AMENDMENT OF SOLICITATION/MODIFICATION OF CONTRACT			BPA NO.		1. CONTRACT ID CODE		PAGE 1 OF PAGES 21		
2. AMENDMENT/MODIFICATION NO. A00004			3. EFFECTIVE DATE 11-04-2016		4. REQUISITION/PURCHASE REQ. NO. 675-17-1-3278-0001			5. PROJECT NO. (if applicable) 675-C SI-150

Request for Information (RFI) Tracking Log**Solicitation: VA-248-16-R-0965****Project: 675-CSI-150****Title: Construct New Mental Health Annex – Viera****RFI # 1 - 67****11/4/2016**

Attachment 2_RFI-4 Reply_675-
CSI-150_Rev. Phase 2

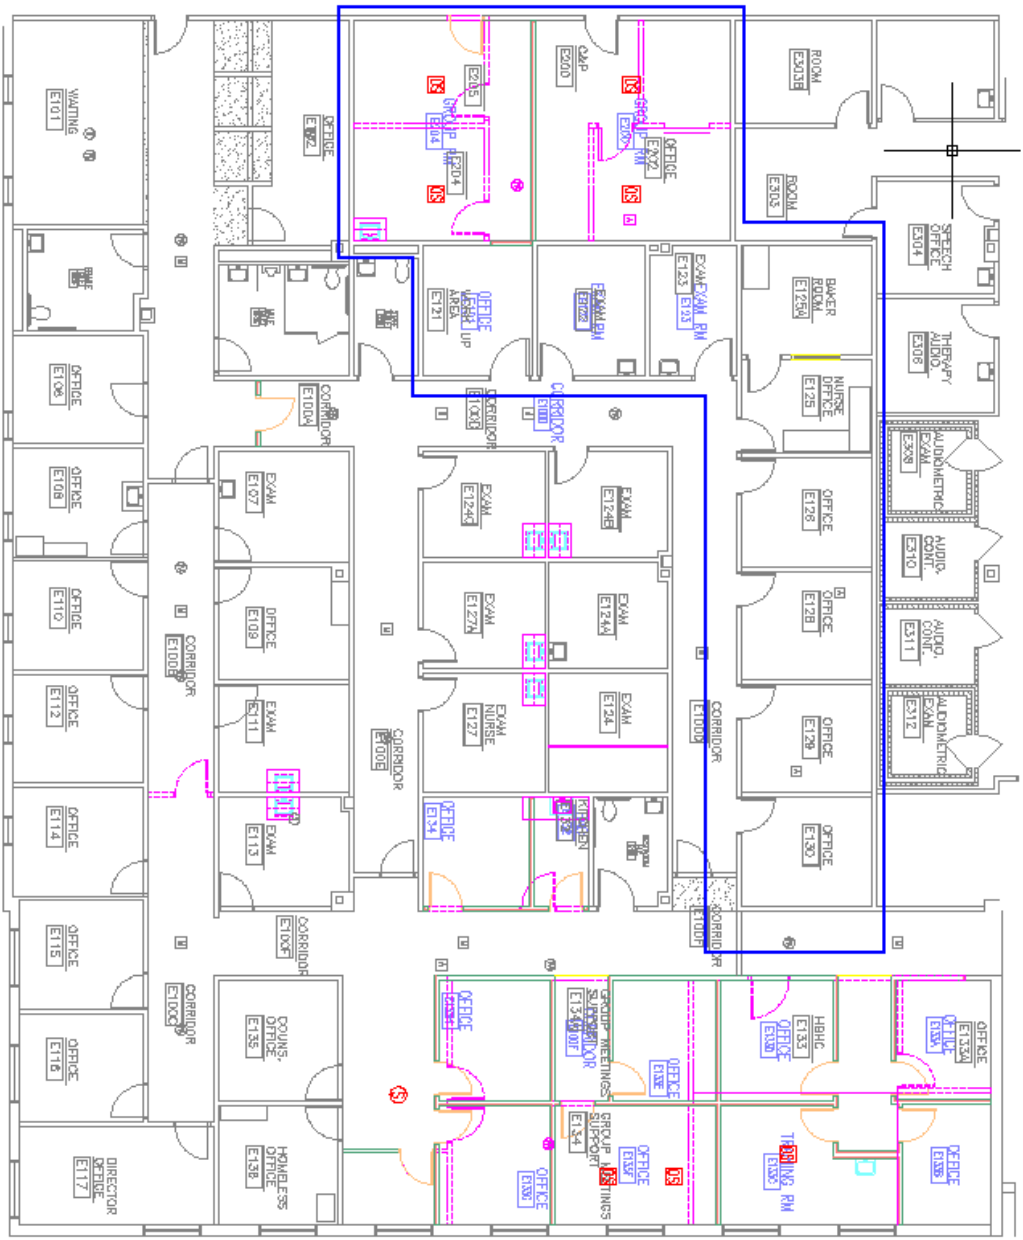
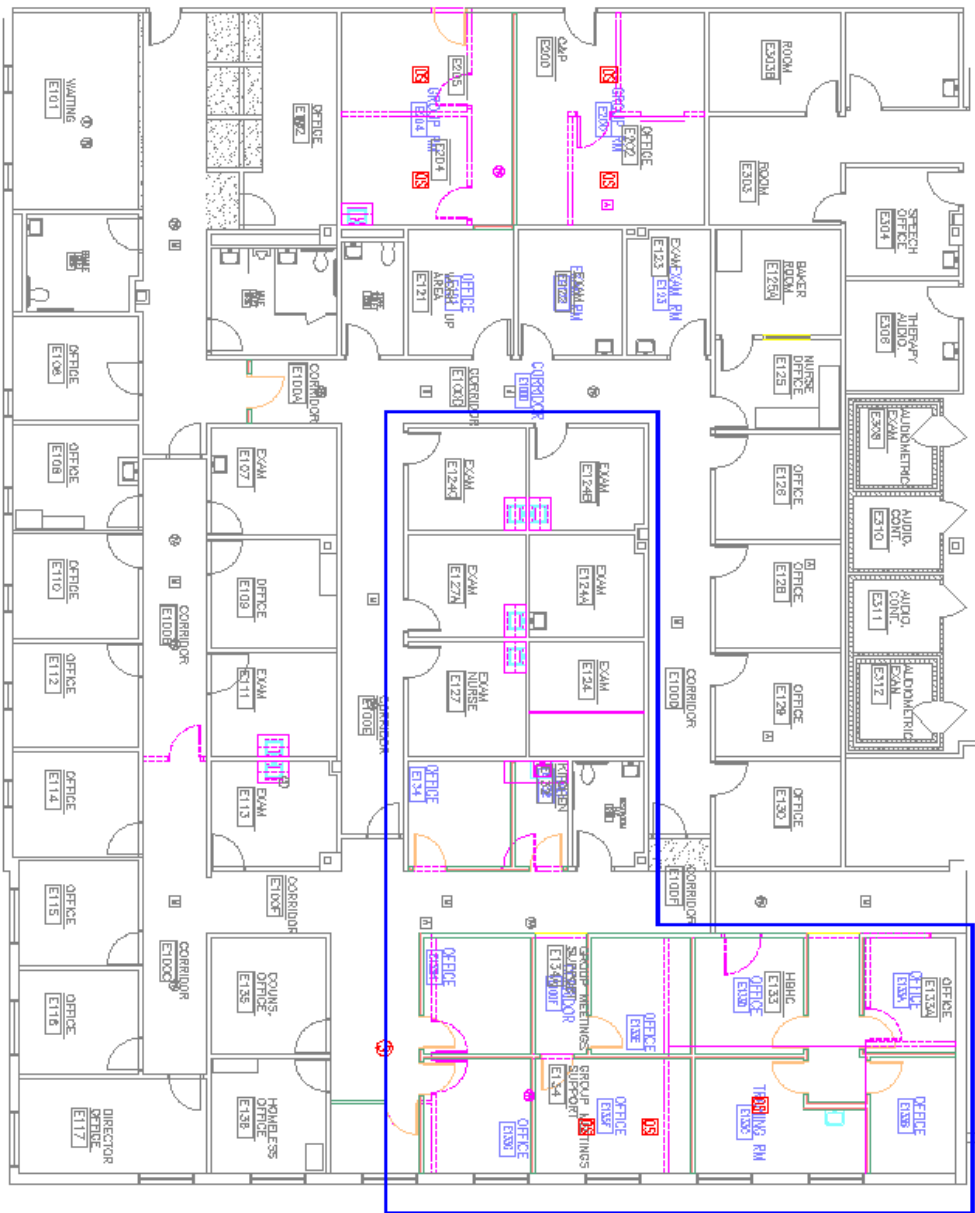
Reply	Submit APA certification		
4	Phase 2 sub-phases shown diagrammatically on the RFP documents do not clearly identify the demarcation points for electrical, fire protection and mechanical systems serving each phase of construction. Request the VA identify the mechanical, electrical, and fire protection systems serving each phase, the systems demarcation points, and clarify how each system is to be managed during each phase. Also, request the VA clarify if any temporary services will be required to operational service areas that are remaining operational during the construction of other phases, but which are serviced by systems that may be impacted during construction of the other phases.	Contract & Purchase Solutions (CPS)	10/28/2016

Reply	HVAC Reply: The HVAC phasing is explained on sheet M001 and MD101 and for the most part it is consistent with phases 2A, 2B, 2C, and 2D. The only exceptions are that phase 2A needs to be expanded by two rooms and phase 2B work is partially completed in phase 2A. See revised Phase 2 Plan in VA248-16-R-0965 A00004, Attachment 2_RFI-4 Reply_645-CSI-150_Rev. Phase 2” for phasing.		10/31/16
5	Request the RFI due date be extended to 5PM, 3 November 2016 to allow for addition time to thoroughly review the large volume of contract documents.	Contract & Purchase Solutions (CPS)	10/28/2016

No issues with HVAC phasing.
